United Nations ST/SG/AC.10/C.3/2018/1-ST/SG/AC.10/C.4/2018/1

Use of the Manual of Tests and Criteria in the context of the Globally Harmonized System of Classification and Labelling of Chemicals (GHS)

Transmitted by the Chairman of the Working Group on Explosives of the Sub-Committee of Experts on the Transport of Dangerous Goods (TDG Sub-Committee) on behalf of the Working Group*

1. This document contains the proposed list of amendments to Sections 1 and 10 of the sixth revised edition of the Manual of Tests and Criteria, including Amendment 1, to take account of its use in the context of the GHS, for consideration by both sub-committees.

"Figure 10.1:OVERALL SCHEME OF THE PROCEDURE FOR CLASSIFYING A SUBSTANCE OR ARTICLE IN THE CLASS OF EXPLOSIVES

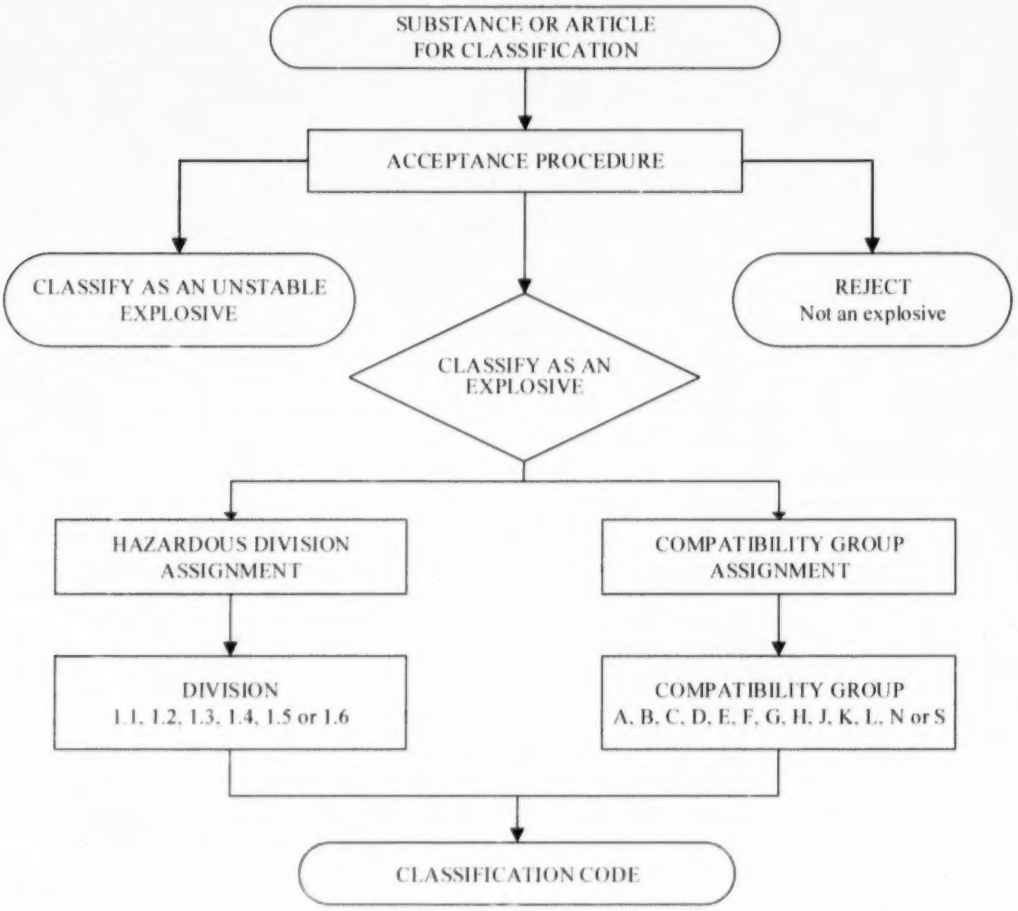
Figure 10.1 Replace the figure and its heading with the following:

"Figure 10.2: PROCEDURE FOR PROVISIONAL ACCEPTANCE OF A SUBSTANCE OR ARTICLE IN THE CLASS OF EXPLOSIVES

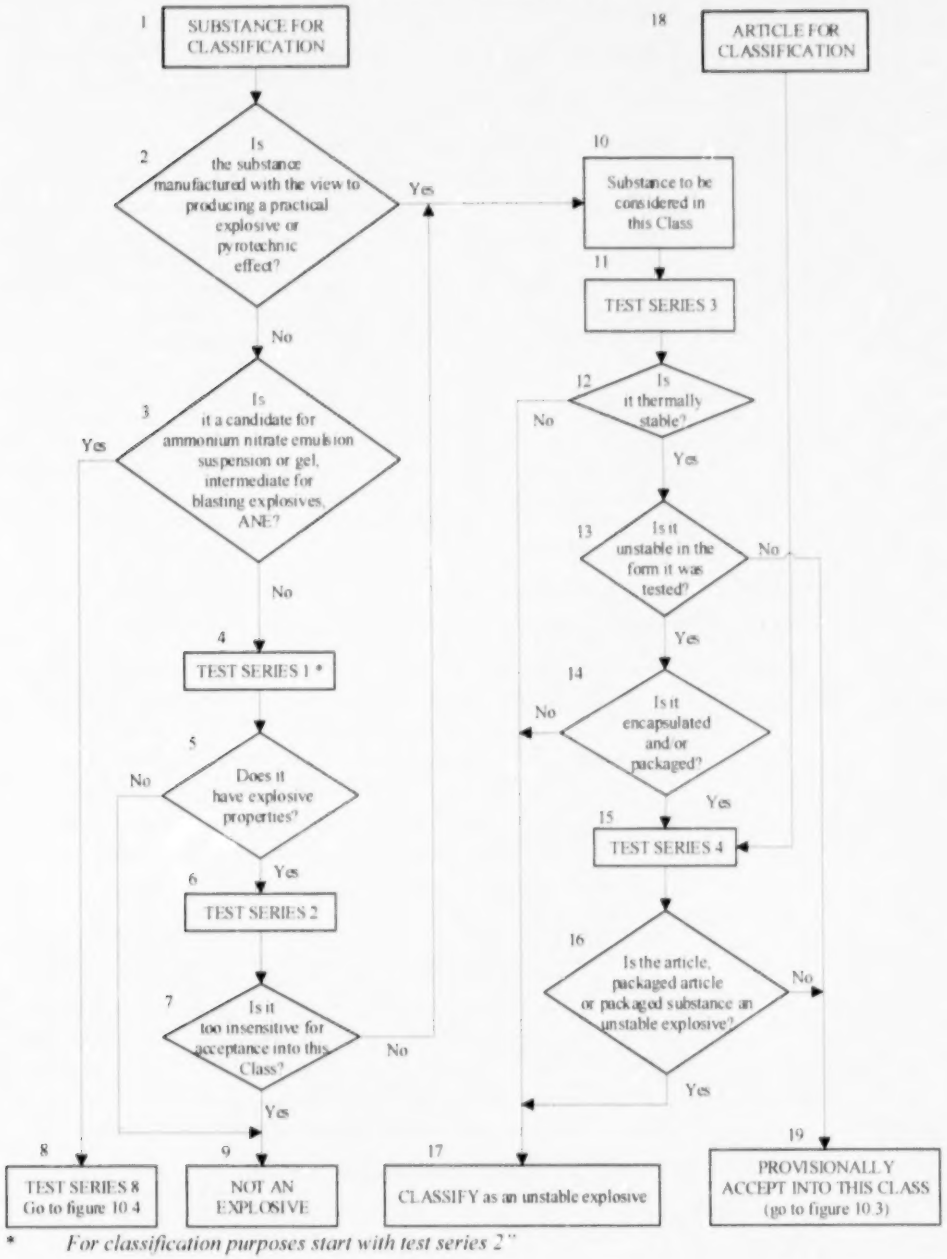
Figure 10.2 Replace current figure 10.2 and its heading with the following:

"Figure 10.4: PROCEDURE FOR AMMONIUM NITRATE EMULSION, SUSPENSION OR GEL, INTERMEDIATE FOR BLASTING EXPLOSIVES

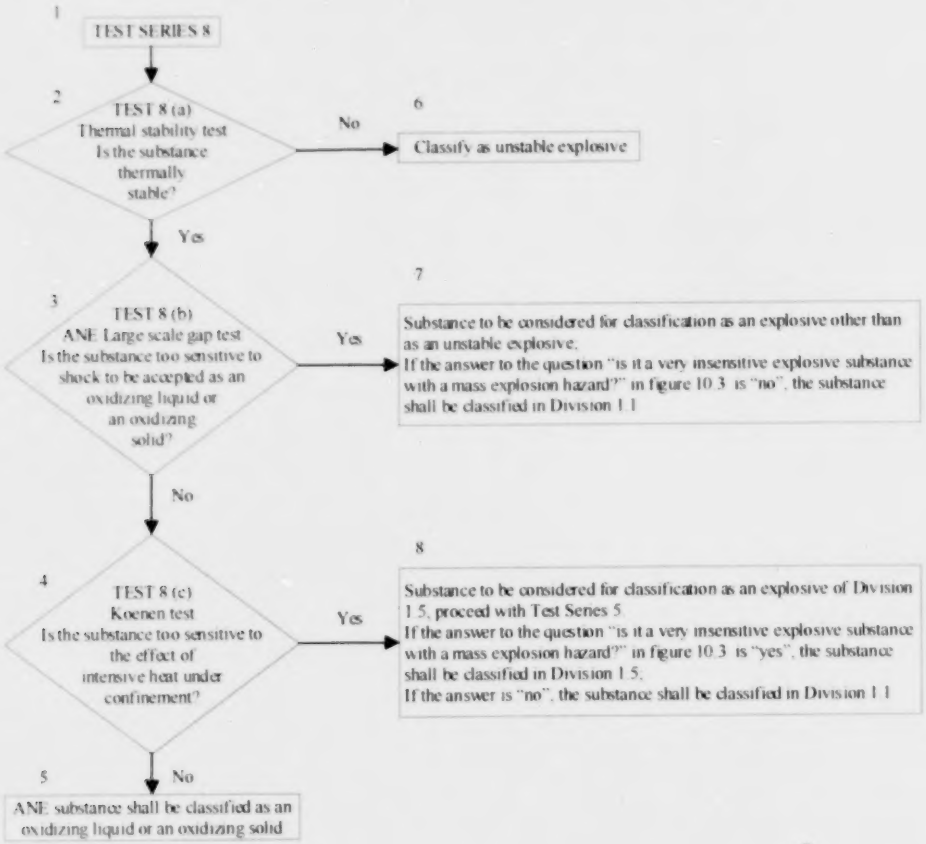
Figure 10.4 Replace current figure 10.4 with the following.

Figure 10.6 (b):
FLOW CHART FOR THE PROVISIONAL ACCEPTANCE OF HEXANITROSTILBENE IN THE CLASS OF EXPLOSIVES

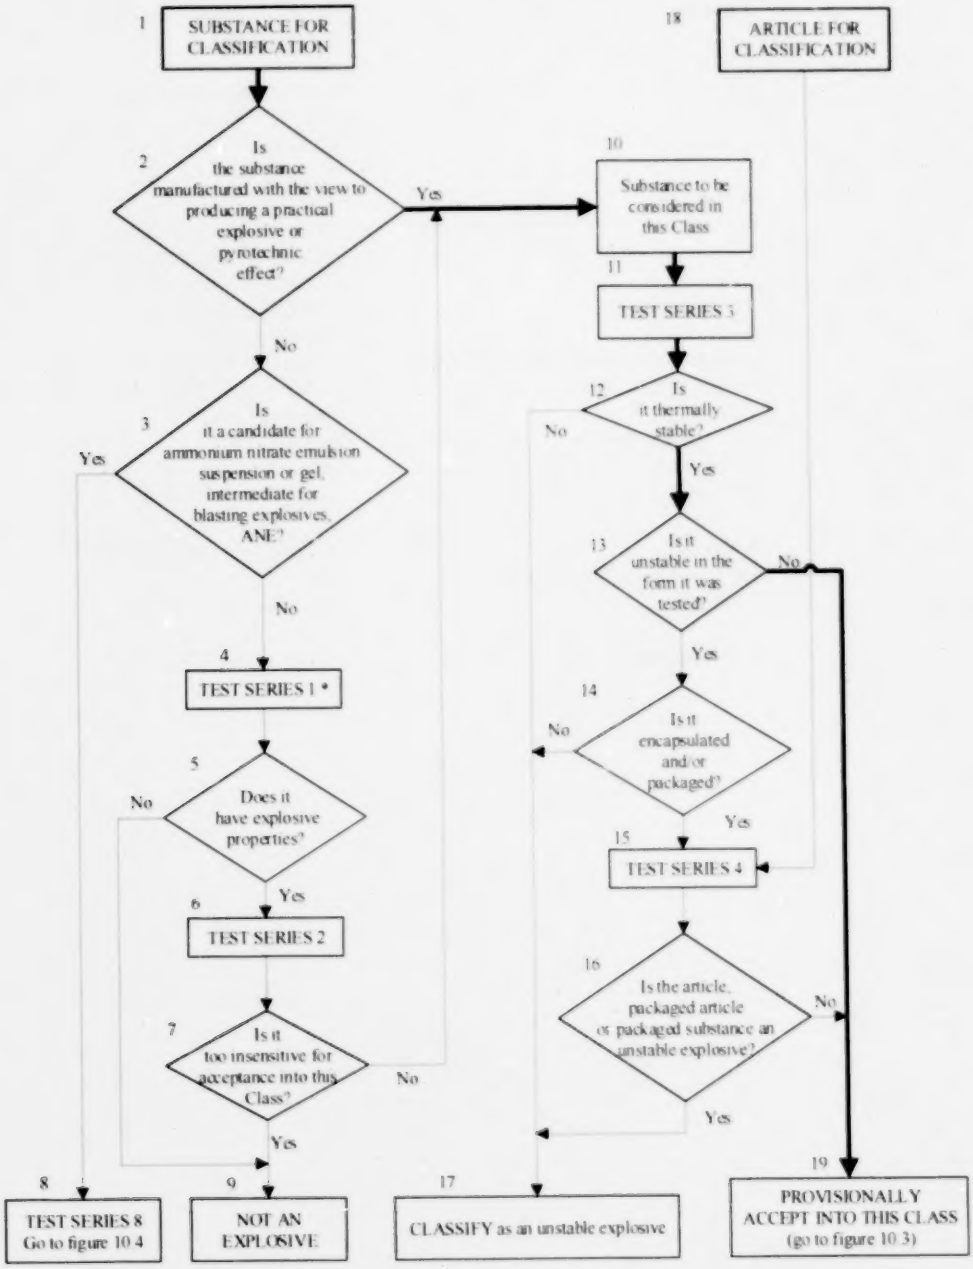
Figure 10.6 Insert the following new Figures 10.6 (a) to 10.6 (d):

"Figure 10.7 (b):
FLOW CHART FOR THE PROVISIONAL ACCEPTANCE OF MUSK XYLENE IN THE CLASS OF EXPLOSIVES

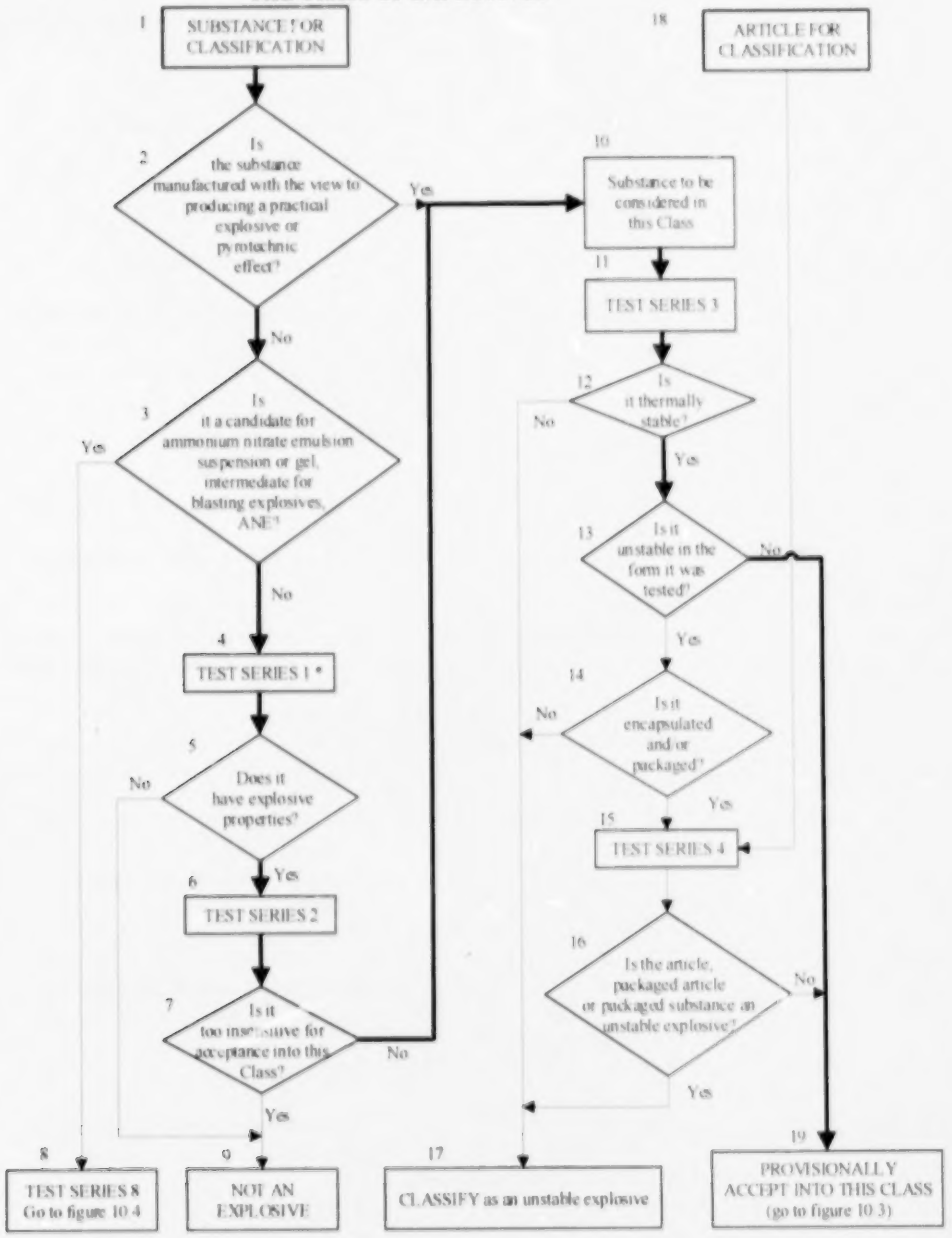
Figure 10.7 (b) Renumber current Figure 10.7 as 10.7 (b) as amended to read as follows:

"Figure 10.7 (d): PROCEDURE FOR EXEMPTION OF MUSK XYLENE FROM THE CLASS OF EXPLOSIVES

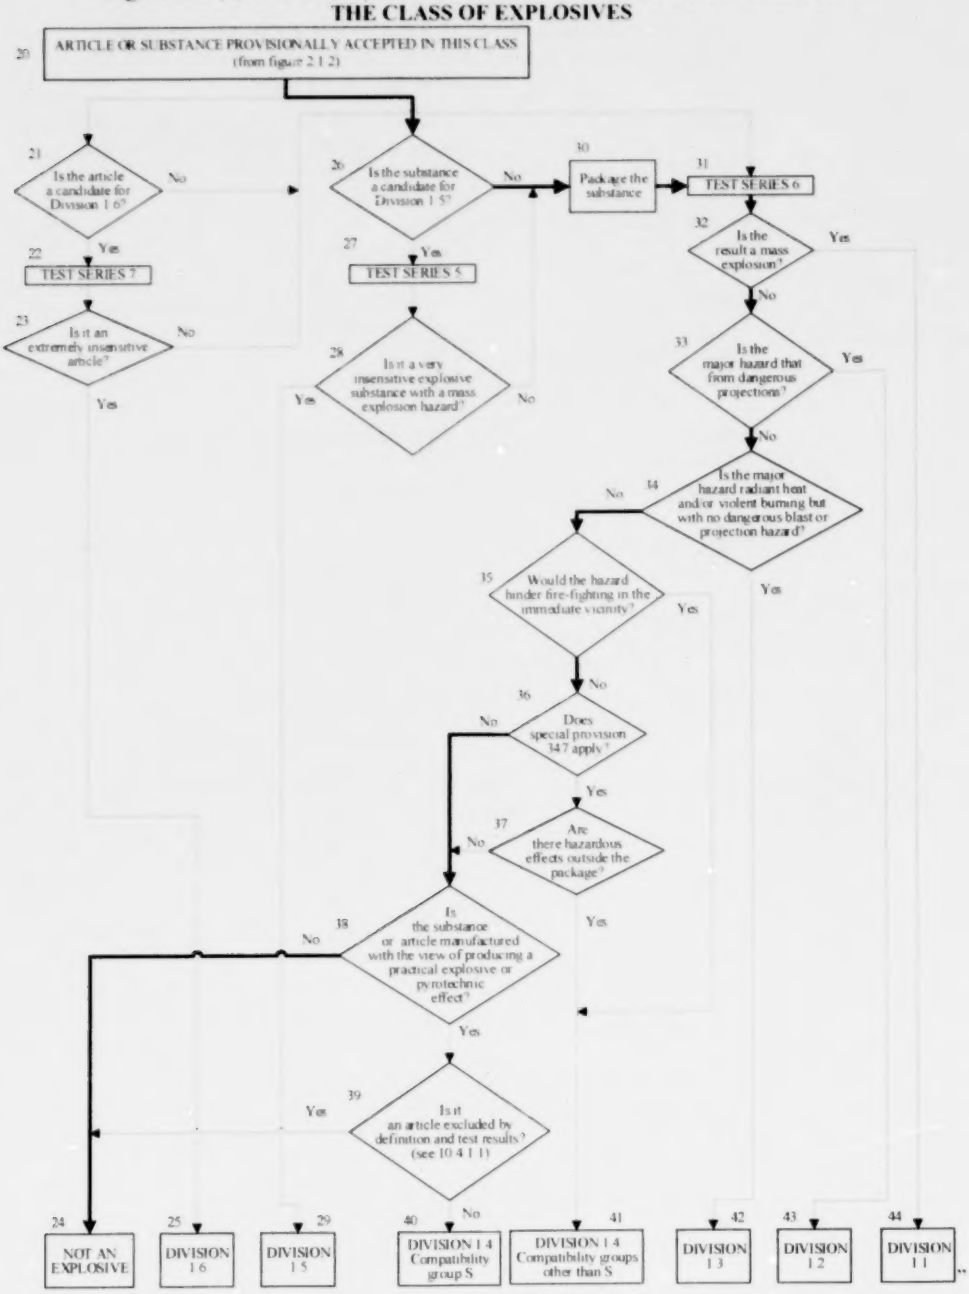
Figure 10.7 (d) Renumber current Figure 10.9 as 10.7(d), and amend to read as follows.
